SN J6801A-04

S E R V I C E N O T E

J6801A DNA

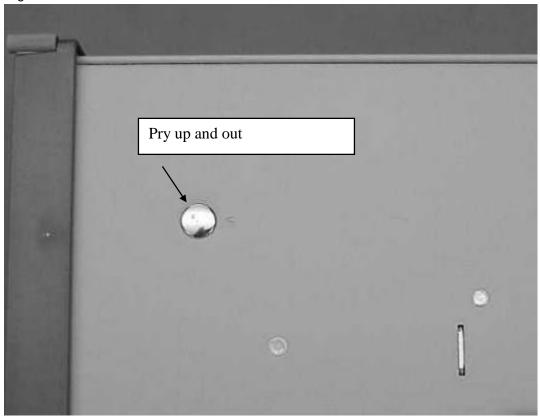
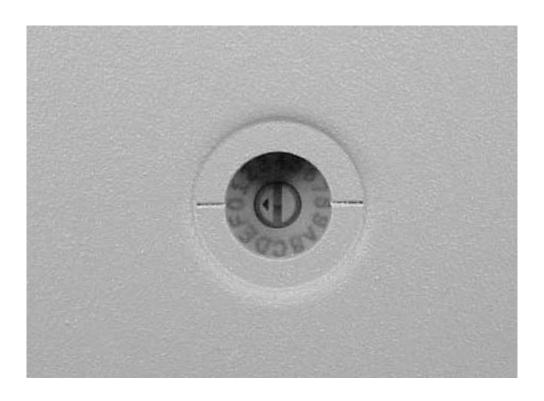
We have determined a root-cause of the DNA failures in daisy chaining. It is due to the Ethernet switch chip on the Ethersync PCA being set to use "flow control" which the should never be used. What we see is that one of "N" DNAs in a chain send a "pause" frame to all switch ports periodically that causes the server to disconnect the DNAs, thus causing a "Connection lost to Server" error message.

The 1st picture shows the bottom of the J6801A. The second picture shows the bottom of the J6801A with the access plug removed and the original setting of the ether sync switch. The 3rd picture shows the "new" setting for the switch. After changing the switch setting the user should replace the access plug.

Changing the switch setting to the correct selection restores proper operation of chained DNA's.
